Cajon Valley Union School District
Bid No. 1614
IT Support Remodel Project

ADDENDUM No. 1

August 14, 2023

SUBMITTAL 03/26/2023
 DRAWING TITLE:
 COVER SHEET
 DRAWING NUMBER:
 E0.1

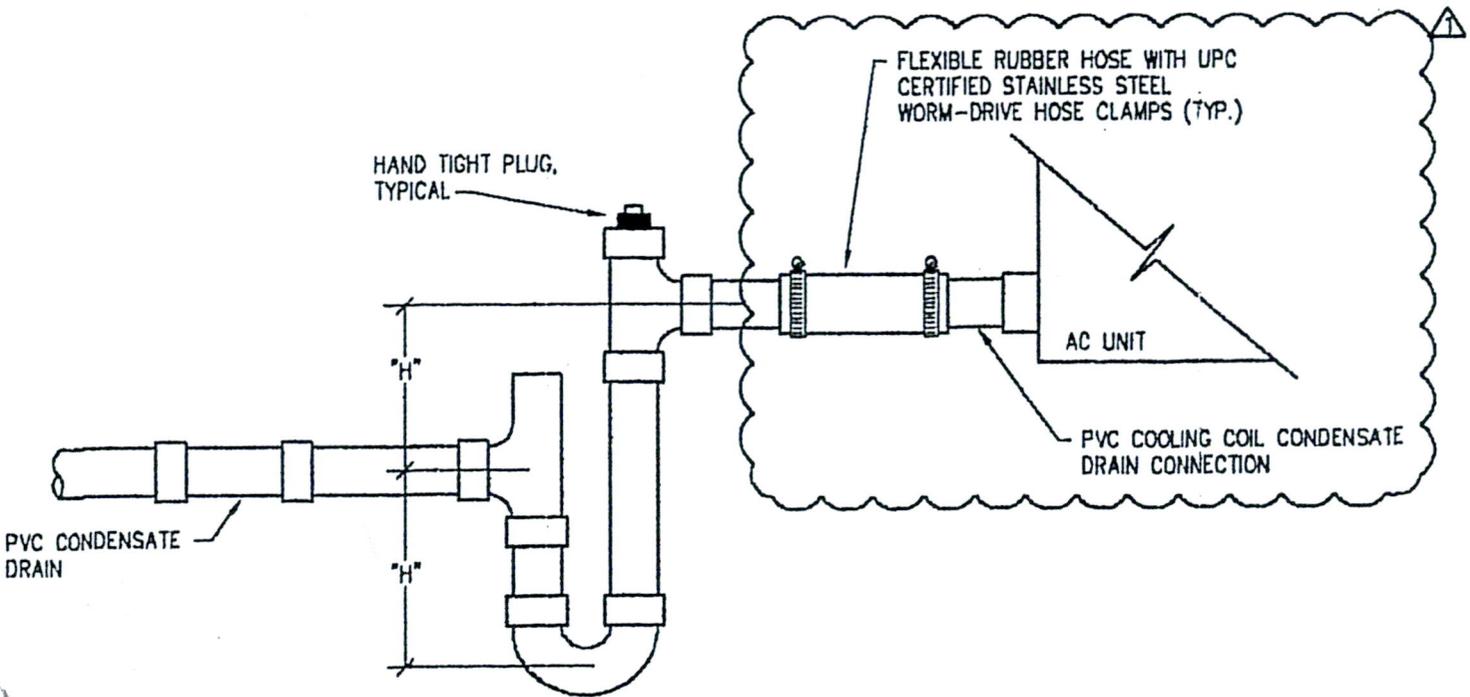
ITEM 1: ADD SHEET E 0.1 TO ELECTRICAL PLANS

ADD Sheet E 0.1, Electrical Cover Sheet (attached) to the Contract Drawings.

Question 6: Are restrooms, vestibule, and storage light fixtures new? If so, Is there a light fixture schedule?

Response: Yes. The fixture schedule is on Electrical Sheet E 0.1. See Addendum 1, Item 1.
